Staff Report to the Ogden Valley Planning Commission

Application Request: Consideration and action for the preliminary approval of Old Snow Basin Ranch Subdivision

Agenda Date: Tuesday, February 27, 2018
Applicant: Sunrise Oaks Capital Funds, LLC

Authorized Representative: Douglas Dance
Subdivision File Number: UVO013018
Alternative Access File Number: AAE 2018-01

Exhibit A-Proposed Subdivision

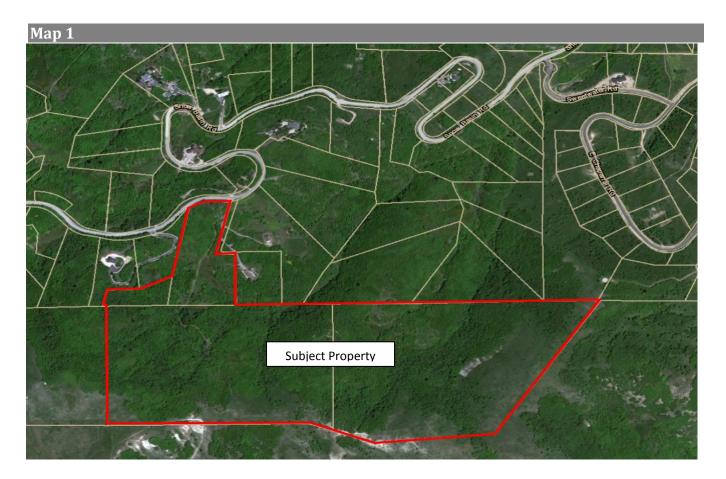
<u>Culinary water and sanitary sewage disposal:</u> A feasibility letter from Weber Morgan Health Department has been provided for the wastewater disposal systems and a Water Allotment has been granted by Weber Basin for the proposed subdivision. Test pits are shown on Lots 1-3 (Phase 1), a condition of approval is recommended by staff that when the applicant moves forward with Lots 4 and 5 (Phase 2), the test pits will be shown on the final drawings as well as all soil test requirements set forth by the Weber Morgan Health Department. The feasibility letter regarding the wastewater disposal systems is dated December 2015; this letter has an 18 month expiration date from the date it was issued. A new letter will need to be provided as part of the final subdivision submittal. Both of these items have been made a condition of staff's recommendation for approval.

The future Lots 2 through 5 will gain access across Lot 1 which fronts and gains access from Old Snowbasin Road by a 18' private right of way (see Exhibit A). As part of the considerations for granting access by a private right of way or access easement per LUC §108-7-31(2) the applicant will need to demonstrate that the "lot/parcel has appropriate and legal access due to historic use, court decree, or the execution of an easement, right-of-way, or other instrument capable of conveying or granting such right;" and requires that "the landowner of record or authorized representative shall agree to pay a proportionate amount of the costs associated with developing a street if, at any time in the future, the county deems it necessary to have the landowner replace the private right-of-way/easement with a street that would serve as a required access to additional lots. The agreement shall be in the form considered appropriate and acceptable to the office of the Weber County Recorder and shall recite and explain all matters of fact, including a lot/parcel boundary description, which are necessary to make the agreement intelligible and show its successive nature."

- 1. Test pits as well as all soil test requirements set forth by the Weber Morgan Health Department must be shown on the final plat for Lots 4 and 5 when the applicant moves forward with the second phase of the development.

- 6. All required agreements will be recorded with the final Mylar to ensure that if, at any time in the future, the County deems it necessary to have the landowner replace the 18' private right-of-way/easement with a street that would serve the additional Lots 2 through 5.

Exhibit B-Ogden Valley Stream Corridor Map

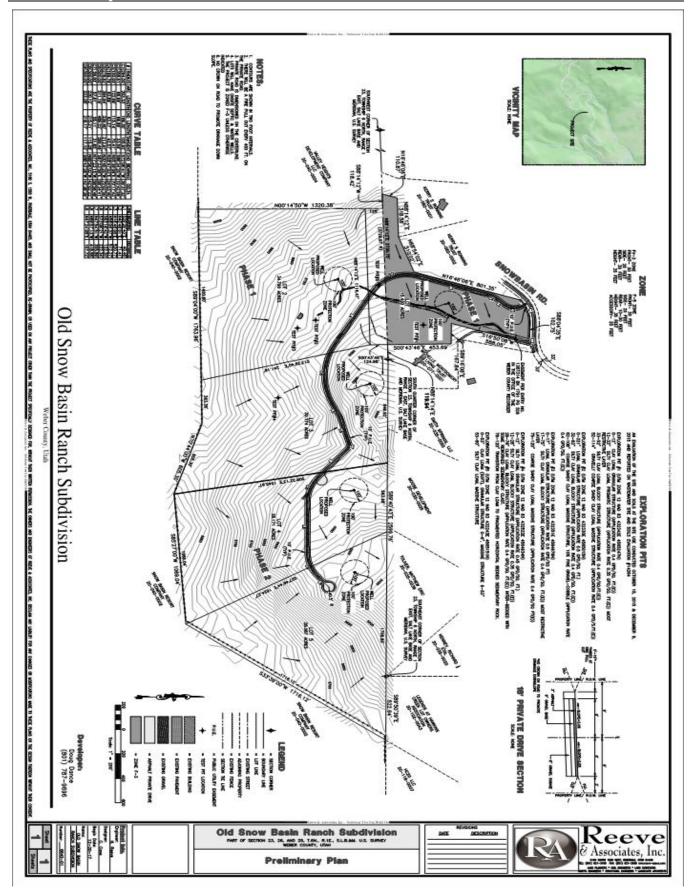
<u>Ogden Valley Sensitive Lands Overlay Districts:</u> Two natural ephemeral streams are located along the northern boundary of the proposed subdivision (see Exhibit B). Due to the location of the streams it is not expected that the development will impact the streams however, the streams will need to be shown on the subdivision plat per LUC §106-1-5(a)(6). The stream corridor is considered an ephemeral stream and requires a 50' setback from the high-water mark per LUC §108-7-23. A condition of approval has been added to staff's recommendation for approval.
